ND-2011-0045
June 23, 2011

Subject: **PSEG Early Site Permit Application**
Docket No. 52-043
Response to Request for Additional Information, RAI No. 25,
Hydrologic Description

ENCLOSURE 1

**Proposed Revisions
Part 2 – Site Safety Analysis Report**

2.4-130

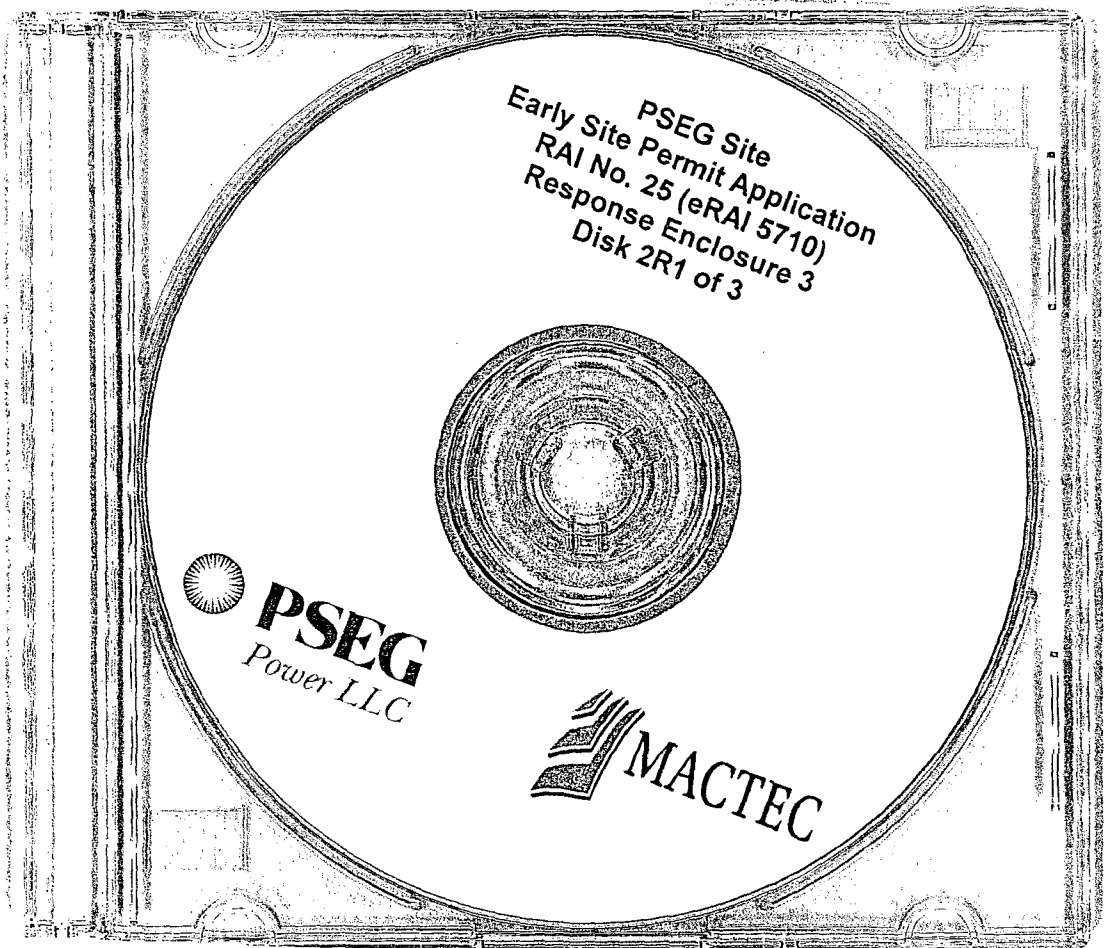
Staff has reviewed the PSEG SSAR and identified that throughout Chapter 2.4 sections, data are provided in text and tables using multiple datum and temporal information. Some tables show datum conversions without discussion of how the conversion was performed. The staff cannot be confident of confirmatory analyses without knowing what data were used and what conversions were performed.

Staff requests that the applicant provide corrected elevation, datum, datum conversion procedures, time period information, and gaging station identification for all surface water records discussed in the SSAR.

During development of the response to RAI 25, discrepancies were identified in the water surface elevations and datum conversions provided in Section 2.4 of the SSAR. Table RAI 25-1 includes the corrected values. Enclosure 2 provides the changes to SSAR Section 2.4 to correct these values. The items that require revision were not used in any subsequent calculations, and do not affect the design basis water levels.
